Report to the Future Melbourne Committee

**Ministerial Planning Application: TPMR-2020-52
383 La Trobe Street, Melbourne****1 June 2021****Presenter:** Larry Parsons, Head of Statutory Planning**Purpose and background**

1. The purpose of this report is to advise the Future Melbourne Committee of a Ministerial Planning Application seeking approval for the demolition of the existing building; and buildings and works for the construction of a multi-storey mixed use building for the land at 383 La Trobe Street, Melbourne (refer Attachment 2 – Locality Plan).

Figure 12. Image of western elevation adjoining Royal Mint (Source: Applicant)

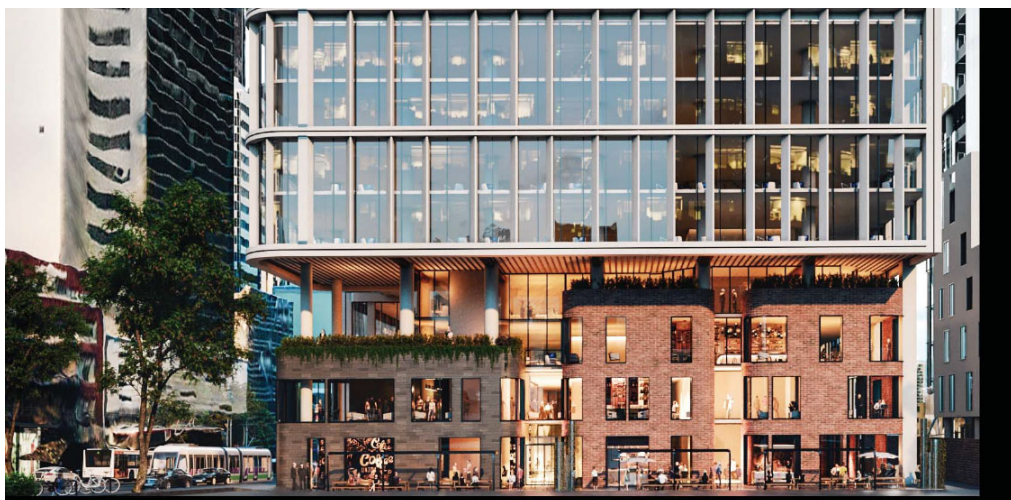
- Despite the podium’s 40 metre height, elements are incorporated into the lower levels which respond appropriately to the heritage wall along the west boundary and heritage status of the adjoining Royal Mint. The podium is also set back from this boundary.

Figure 13. Adjusted floorplate and setbacks (Source: Applicant)

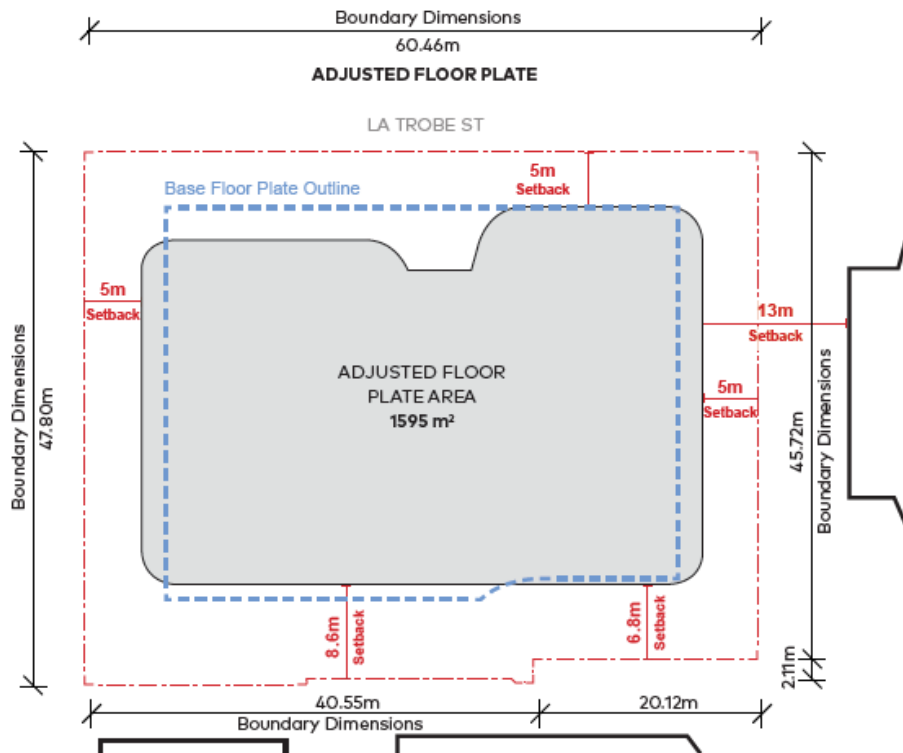
The tower floorplate has been adjusted. However, a minimum 5.0 metre setback is maintained to all boundaries of the site and the proposed floorplate will not result in an increase in the base compliant floorplate area (indicated by blue dotted line).
